HERBAL HOUSE

Planning Amendments - Minor Material Amendments Document

25th January 2017

863 - Herbal House - Outline Schedule of Changes

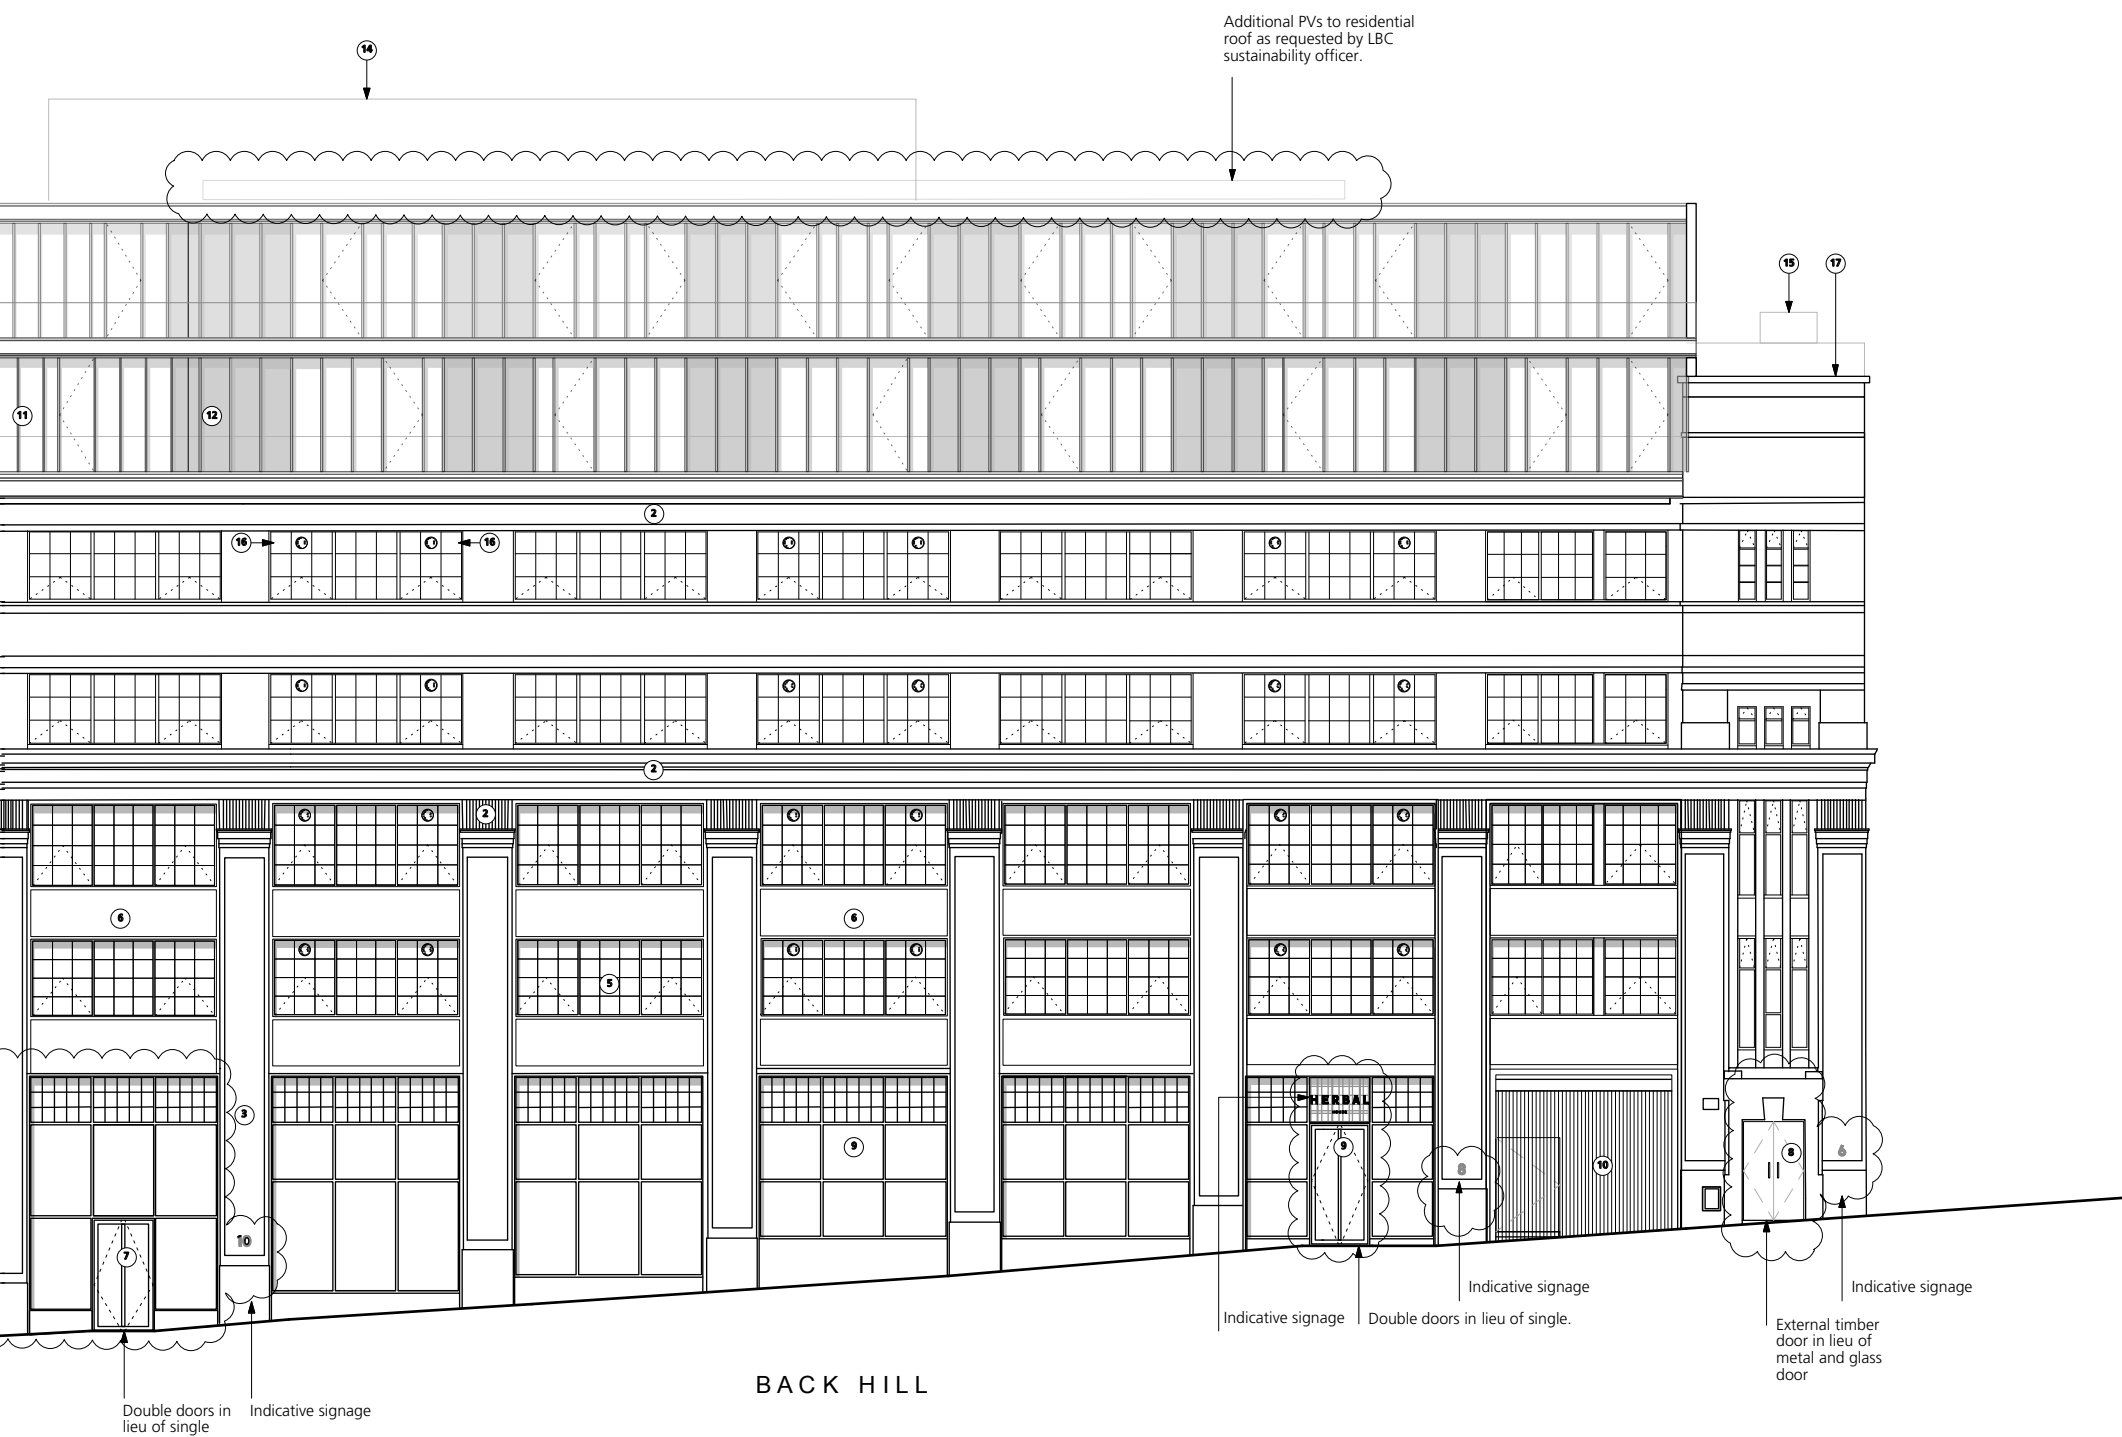
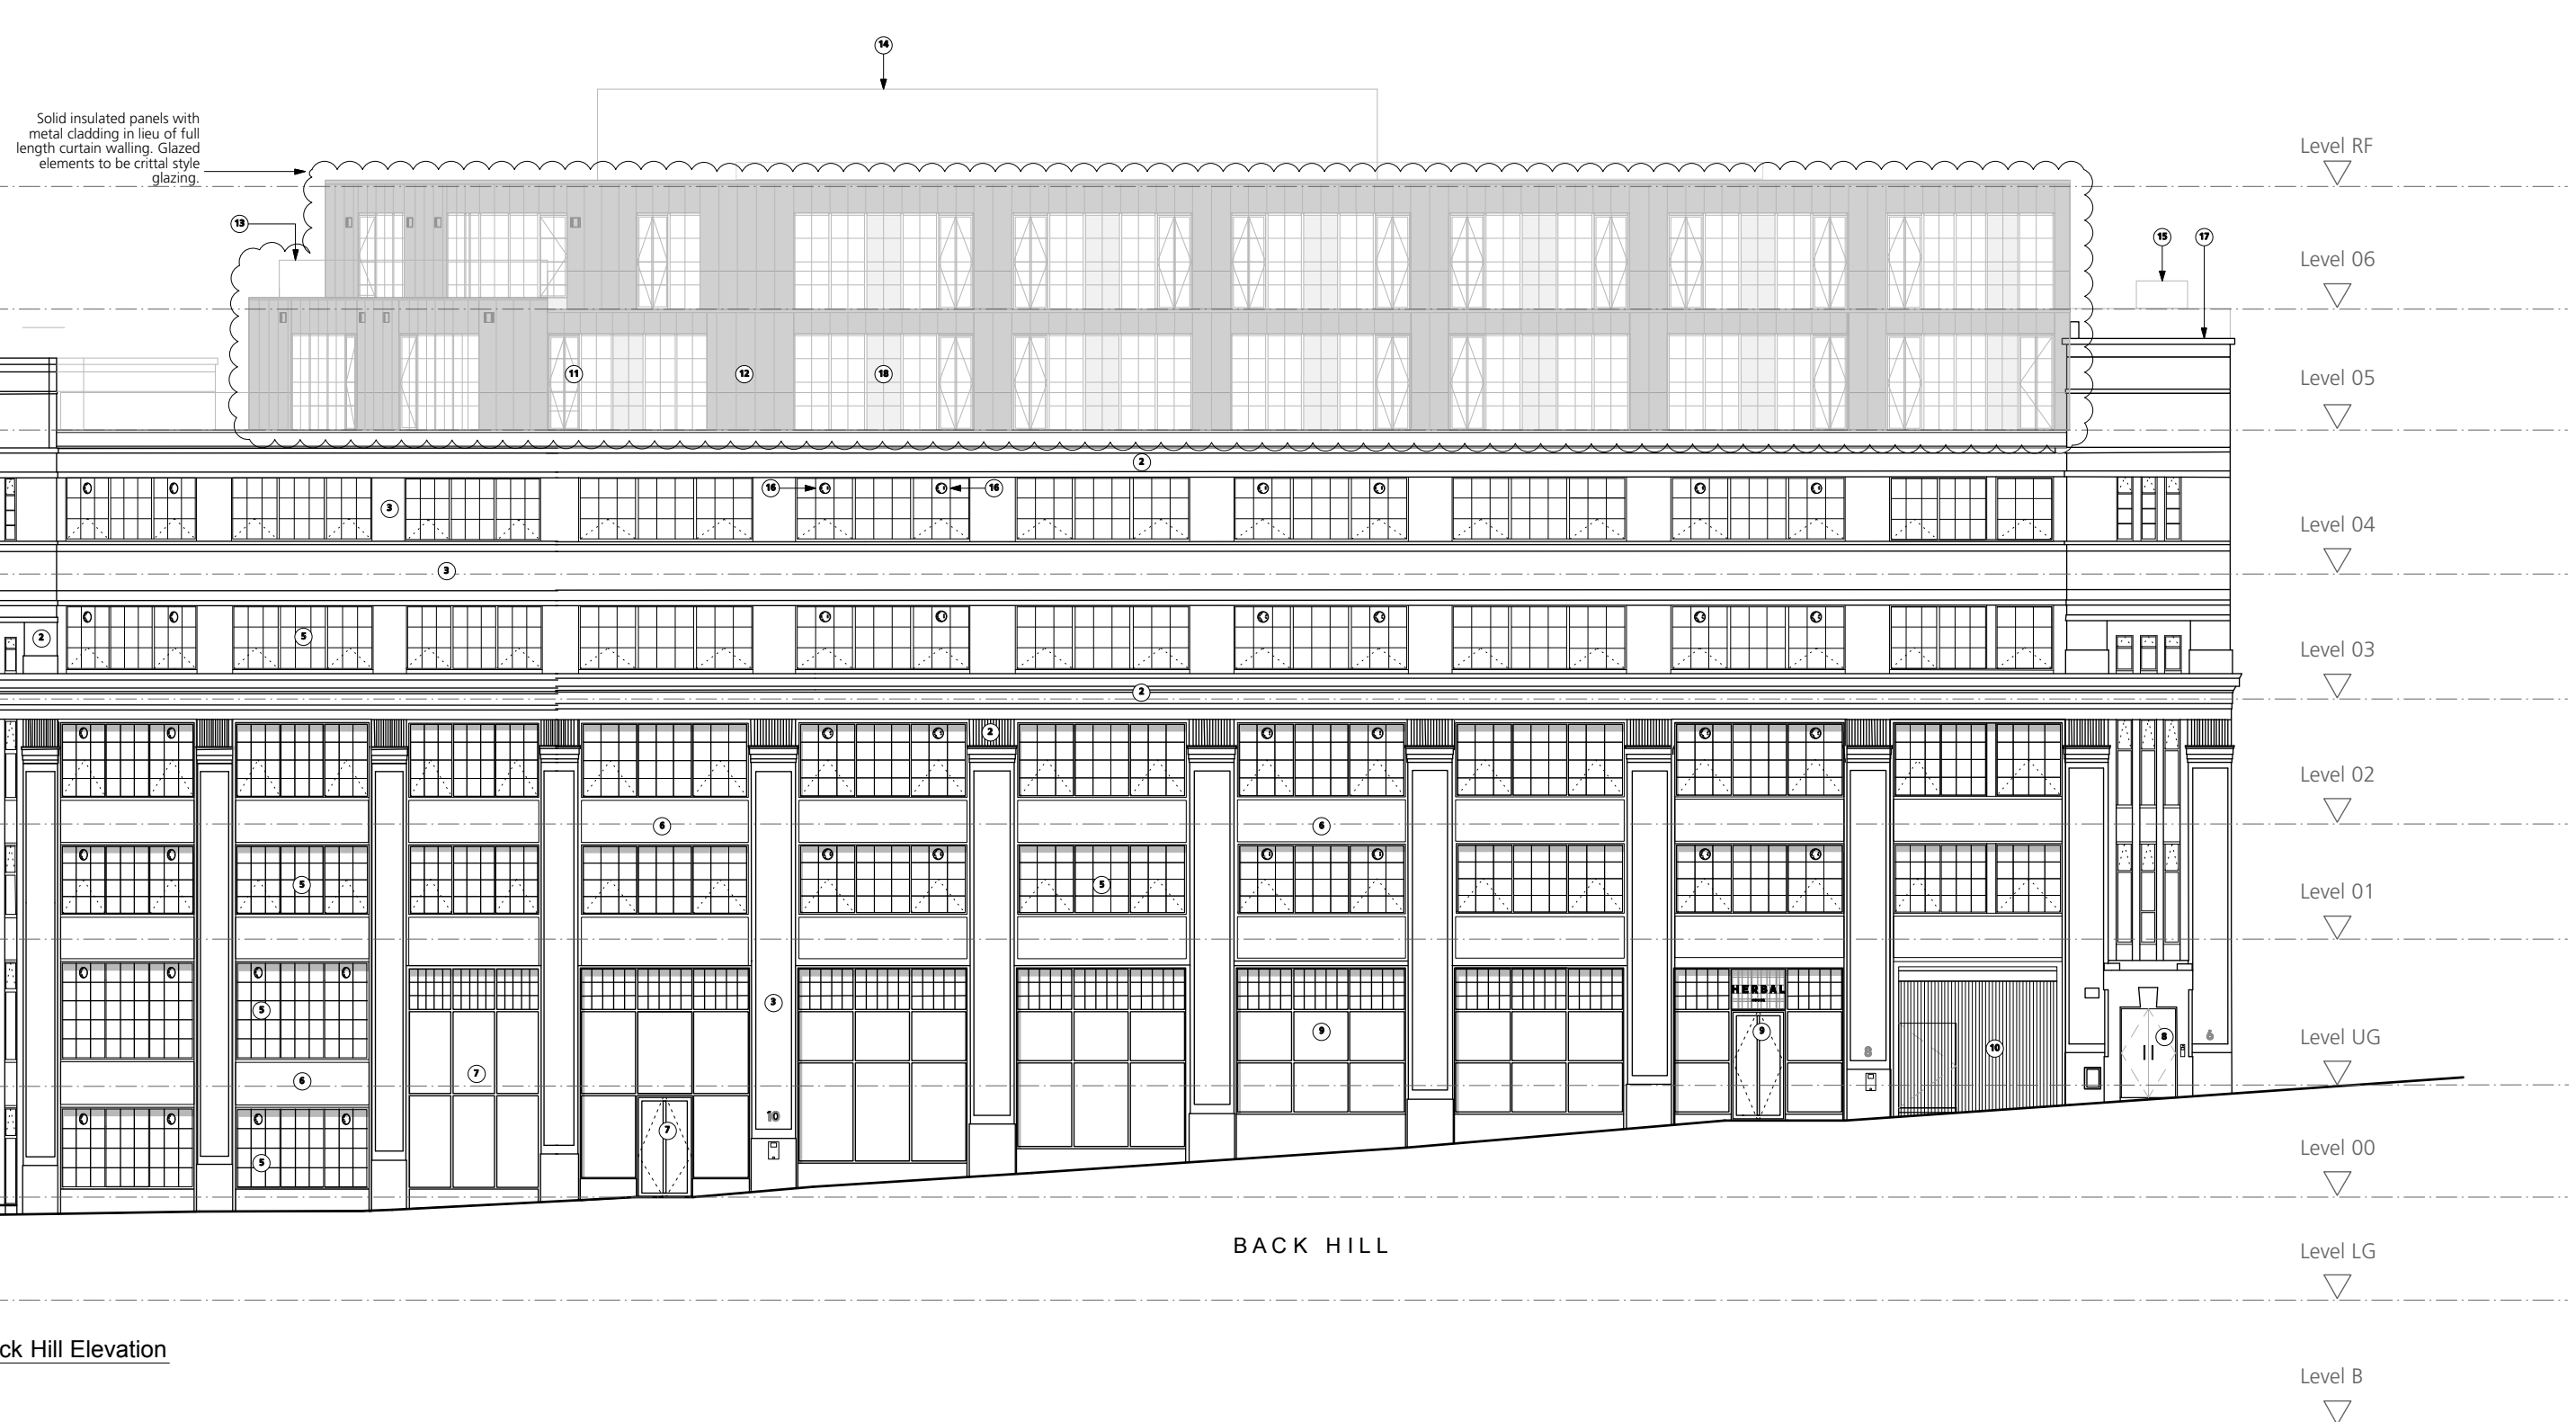
Original Scheme	Revised Scheme
DRAWINGS			
		(863_GA_05, 863_GA_06, 863_GE_01, 863_GE_02)	
Elevations			
(863_PL_GE_01, GE_02)	1.01	Back painted glazed curtain walling to solid elements of 5th and 6th floor extension	Metal cladding to insulated panels to solid elements of 5th and 6th floor extension
	1.02	Full height glazed curtain walling panels to 5th and 6th floor extension	Crittall style glazing to 5th and 6th floor extension
	1.03	n/a	New insulated back painted crittall style glazing
	1.04	Single doors out to residential terraces	Double doors out to residential terraces

- ⑨ New crittal style glazing with glazed entrance double doors to upper reception
- ⑩ New metal cladding with access door (to existing substation) with concealed ventilation louvre at high level
- ⑪ New unisited curtain wall system (translucent glass)
- ⑫ New solid elements faced with patinated metal panel with solid backing to act as solar shading
- ⑬ New perforated metal balustrade
- ⑭ New acoustic screen surrounding tenant plant on roof (set back from edge of building, not visible from public highway)
- ⑮ Lift overrun
- ⑯ Proposed ventilation grills set within crittal window panes

- 9 New crittal style glazing with glazed entrance double doors to Upper reception
- 10 New metal cladding with access door (to existing substation) with concealed ventilation louvre at high level
- 11 New crittal style glazing
- 12 New insulated solid panels clad with metal cladding
- 13 New perforated metal balustrade
- 14 New acoustic screen surrounding tenant plant on roof (set back from edge of building, not visible from public highway)
- 15 Lift overrun
- 16 Proposed ventilation grills set within crittal window panes
